Re: Invenergy Thermal Development LLC's Application to Construct and Operate the Clear
River Energy Center in Burrillville, Rhode Island
Docket No.: SB-2015-16

CLEAR RIVER ENERGY LLC's RESPONSES TO
THE RHODE ISLAND DEPARTMENT OF HEALTH'S FIRST
SET OF DATA REQUESTS

TO: Rhode Island Department of Health DATE: April 20, 2017
FROM: Michael Feinblatt, ESS Group, Inc. ESS PROJECT NO.: I108-013.04
SUBJECT: Clear River Energy Center RIDOH EFSB Advisory Opinion Responses
COPY TO: Invenergy, APS

Figure 5. Calculated magnetic-field level at average loading for proposed conditions in XS-1. Note that the east-to-west or west-to-east transfer case will not affect the modeled levels of the magnetic field from the 3052 on the CREC ROW

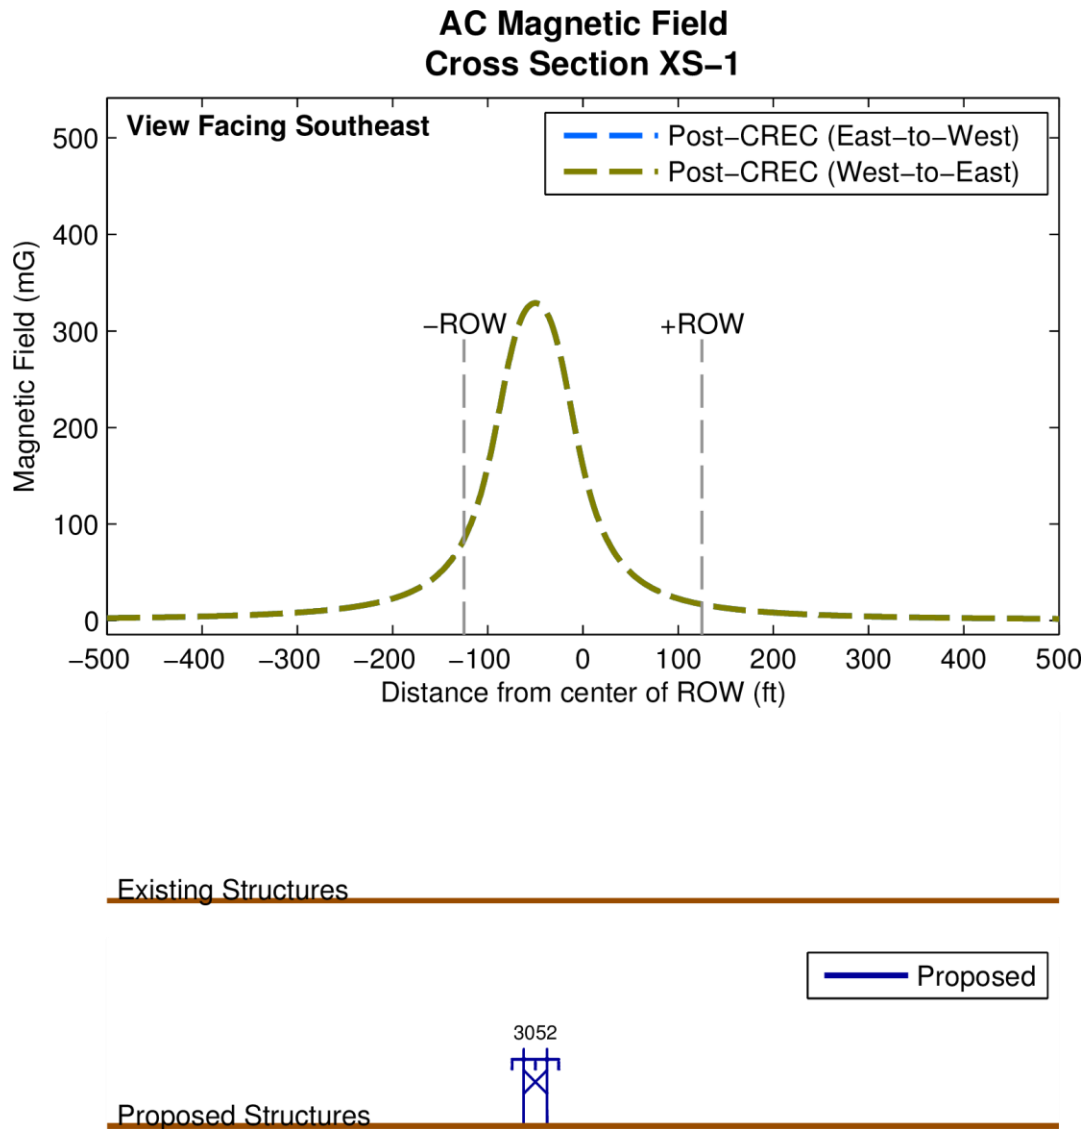
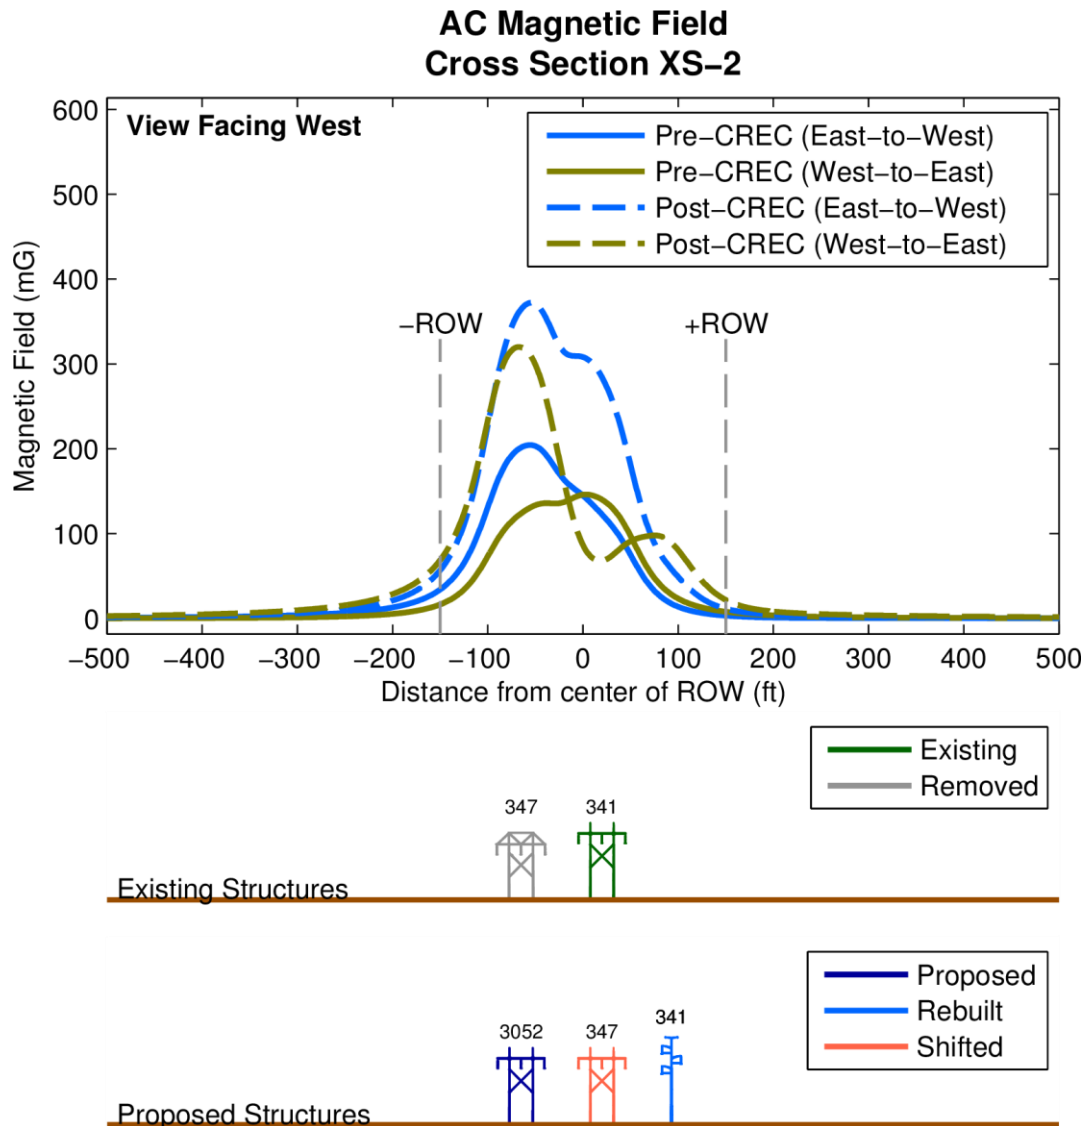
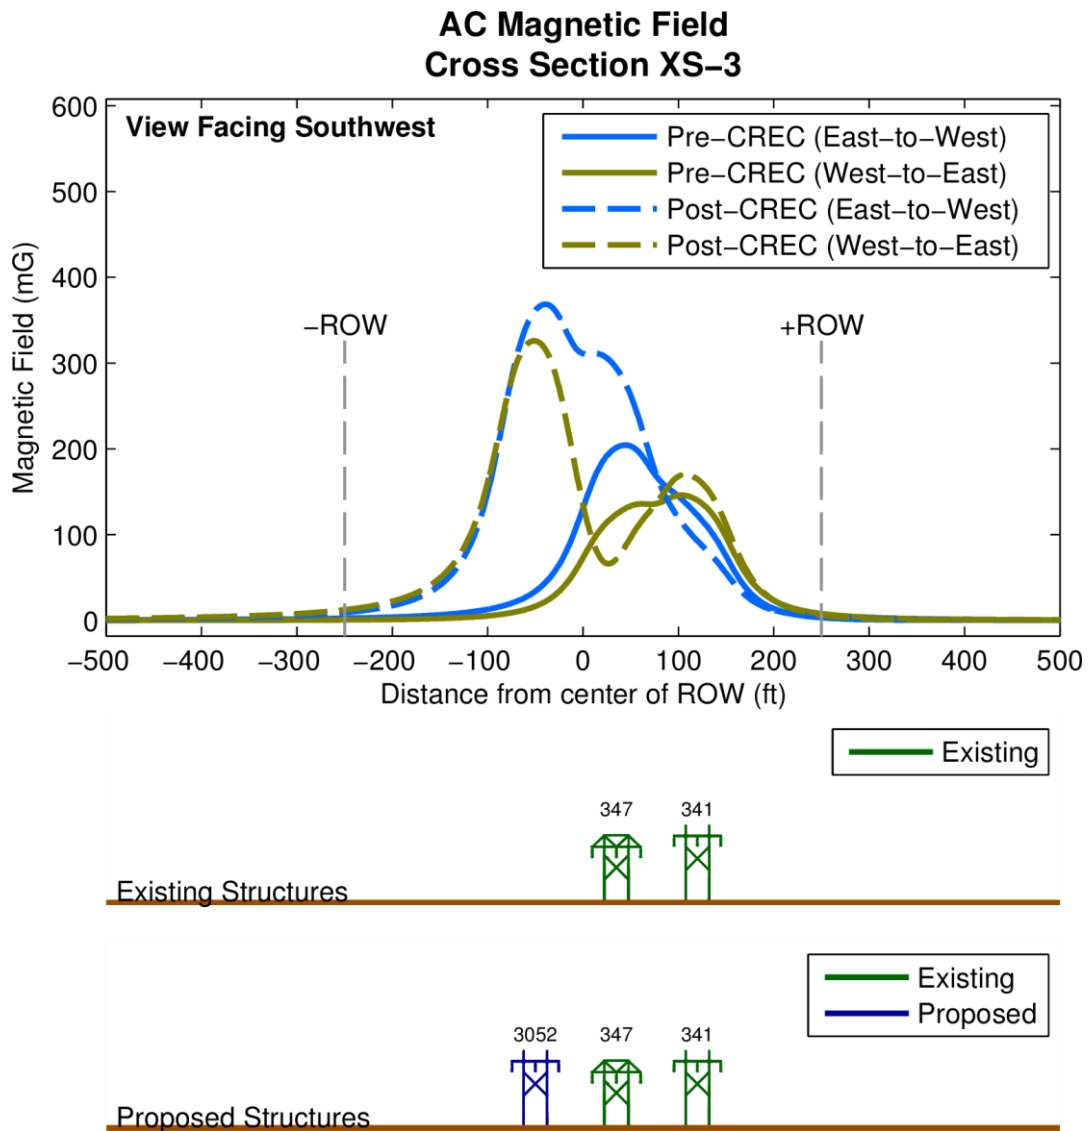
REQUEST 1: The Clear River Energy Center (CREC) application included an analysis of projected increases in electric and magnetic field impacts associated with the addition of a third set of transmission lines. That analysis showed that the proposed new lines would not significantly increase the strength of the electric fields, but, under peak load conditions, would increase magnetic fields within 100 feet of the Right of Way.

- *Please supply an update to that analysis, which includes the magnitude and location of electric and magnetic field impacts associated with the most current proposed configuration.*

Calculations at various locations on and beyond the ROW are summarized in Table 4 and Table 5 for all modeled sections. Graphical results of magnetic field calculations are shown in Figure 5 through Figure 7. As expected, the addition of the heavily-loaded 3052 Line to the ROW increases the maximum magnetic-field level on the ROW as well as at the ROW edges. The edge of ROW magnetic-field level in XS-3 where the ROW is very wide, however, remains 12 mG or less under average loading cases. The maximum magnetic-field level under average loading on the XS-2 ROW is similar to that of XS-3, but the narrower ROW width in XS-2 results in higher magnetic-field levels near the ROW edge, primarily on the southern side of the ROW (69 mG) when the 3052 Line is operating. Similarly, in XS-1, the shorter distance from the structures to the ROW edge results in a higher magnetic field level (84 mG) at one ROW edge. It is important to note, however, that even operating CREC at 1046 MVA the magnetic-field levels are all well below the Reference Levels recommended by ICES and ICNIRP.

Figure 1 - Noise Level Contours for Baseload CREC Operation

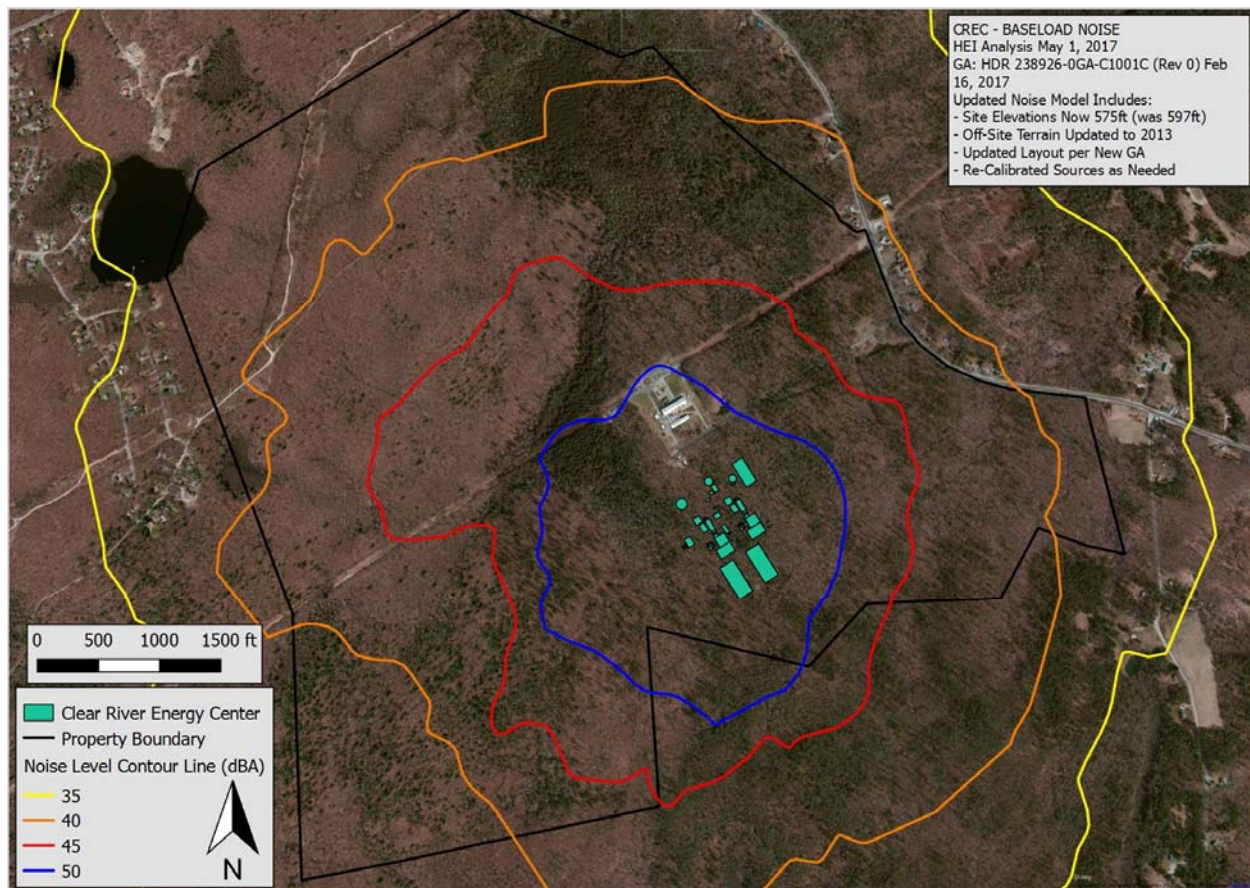
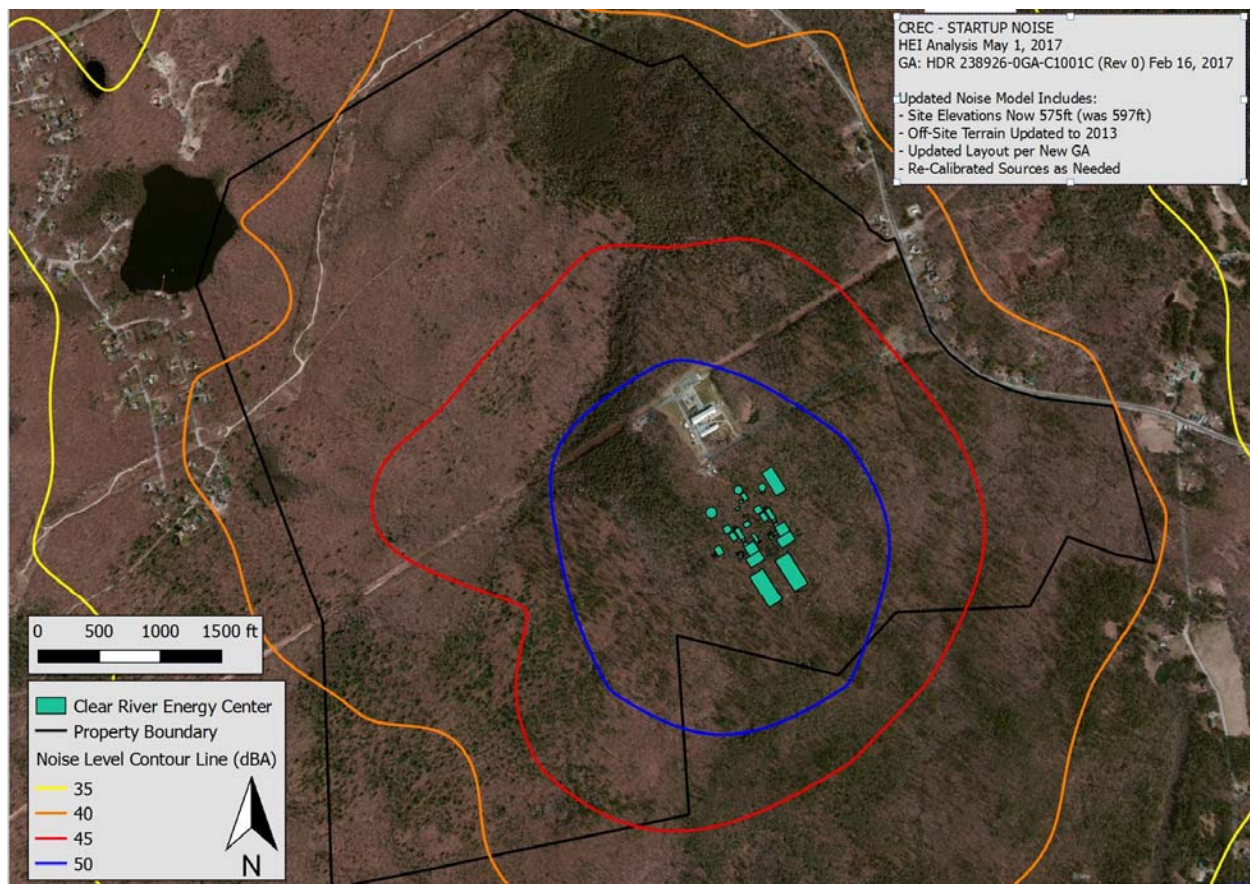
RIDOH Data Request: The noise analysis submitted as part of the CREC application reported modeled noise impacts associated with construction and operation of the proposed facility at five neighboring locations. Please provide an update of that analysis which shows the magnitude of the noise impact at each of those locations, as well as maximum offsite impacts.

CREC Response: The noise level analysis of both baseload and start-up operations has been updated to reflect the most current design of the CREC (February 2017). The results of this analysis are shown as noise level contours in the figures below. The results at each of the five analysis points are listed in the table below. These levels are approximately 1 dBA lower than those reported in the CREC permit application for baseload operations, due to additional noise mitigation measures being added to the design of the CREC since the application. Refer to the Noise Level Evaluation Report (October 2015) for more information on noise modeling methodology, analysis locations, and input data.

Location	Baseload Operation (dBA)	Start-Up Operation (dBA)
M1	41	42
M2	39	40
M3	38	40
M4	38	40
M5	32	34

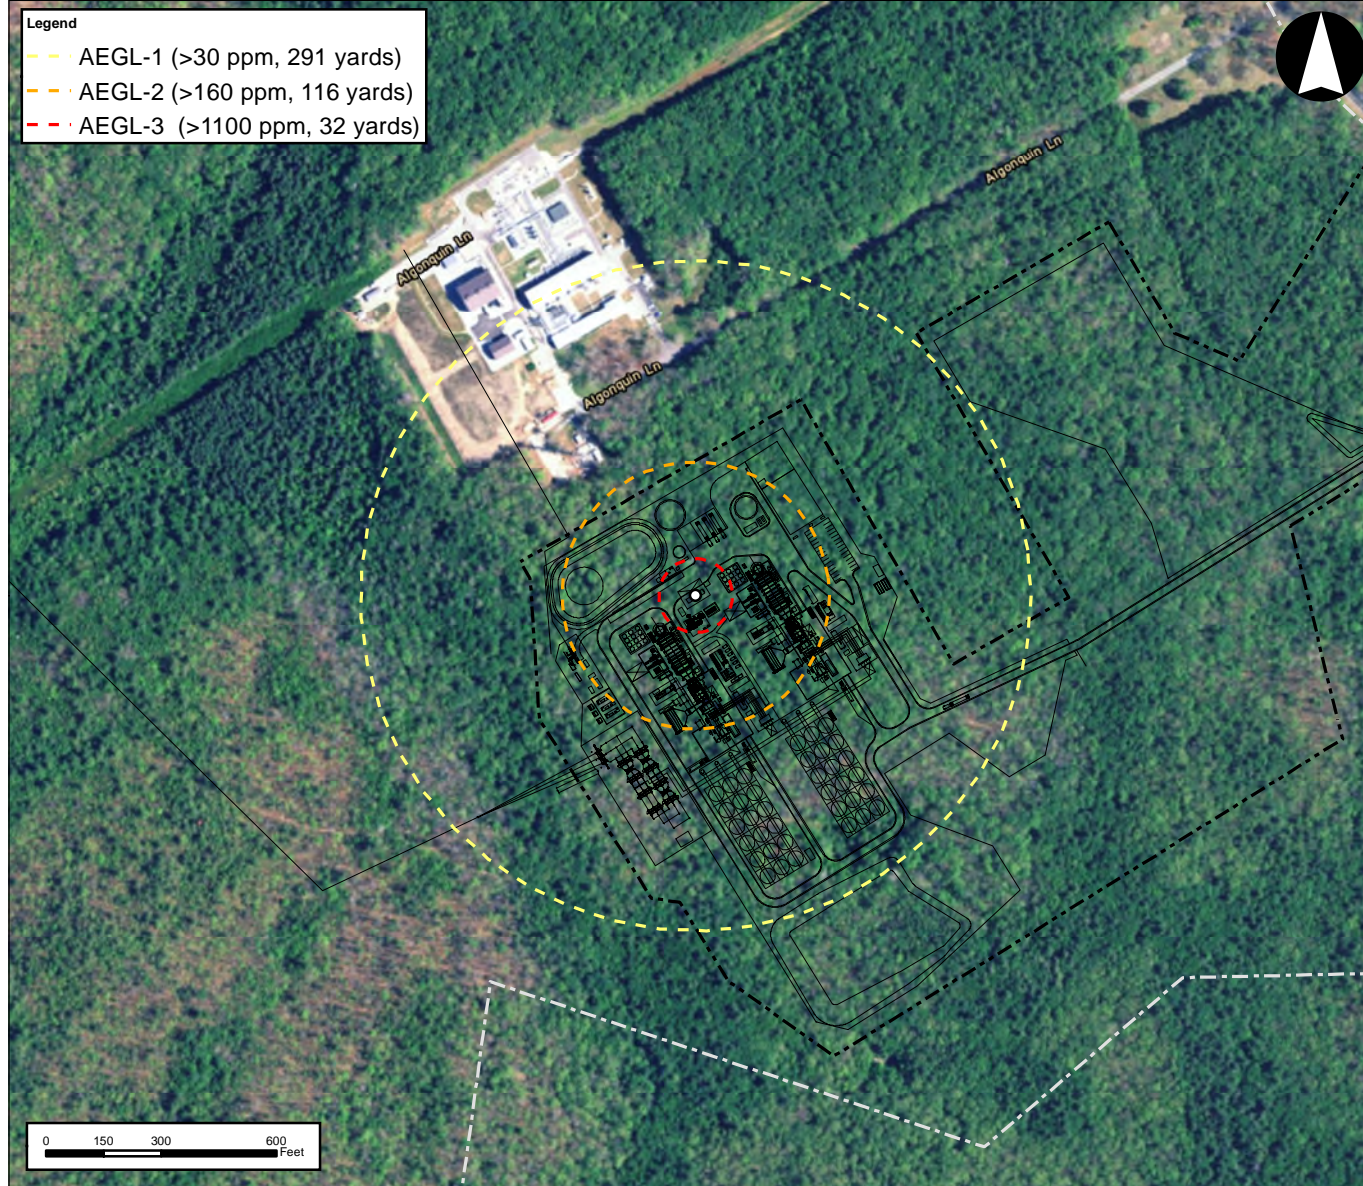
- Invenergy should conduct a worst-case off-site consequence analysis for ammonia storage using more conservative assumptions.

- *Although CREC is not subject the Risk Management Program, a worst-case accidental release scenario was previously completed to assess the potential consequences in the extremely unlikely event of a release of the 19% aqueous ammonia into the containment area. The results of that analysis showed that all of the areas in which the in-air ammonia concentration would exceed the AEGL-1 level are within the Project and/or Spectra site, which is private property not accessible to the general public.*

The ALOHA model was previously run using Stability Class A and an ambient temperature of 104°F, which was the highest daily maximum temperature for the site during the past three years, which is the ambient temperature required by the “Risk Management Program Guidance for Offsite Consequence Analysis” for the worst-case release modeling. In its Advisory Opinion, the RIDOH recommended that the ALOHA model be run using Stability Class F and at an ambient temperature of 85°F to be more conservative.

Subsequent to the issuance of the RIDOH Final Advisory Opinion, the storage volume of the CREC ammonia storage tank has been reduced from 40,000 to 27,000 gallons. CREC has proposed to employ passive evaporative controls to mitigate the consequences of an accidental release of ammonia from its on-site storage tank. The passive control system will consist of industrial-grade plastic balls placed in the bottom of the containment area surrounding the storage tank. In the event of an accidental release of aqueous ammonia into the containment area, the liquid would pass between the balls and spread out on the concrete base. The floating balls will reduce the area available for volatilization to approximately one-tenth of the total surface area of the liquid. The balls will also block the wind, greatly reducing the wind speed at the surface of the liquid, further reducing the rate of volatilization.

CREC is also now proposing to utilize a misting system within the ammonia storage tank containment area to reduce the concentration of any aqueous ammonia within the containment area by 33% in the event of a release.

The results of the revised ALOHA modeling analysis, based on the reduced storage volume and the proposed control systems and using the modeling inputs recommended by the RIDOH, are shown graphically on the attached figure. As shown on the attached figure, even under the most stable wind conditions (Stability Class F), the impact areas are all within the CREC and Spectra property lines, within areas not accessible to the public.
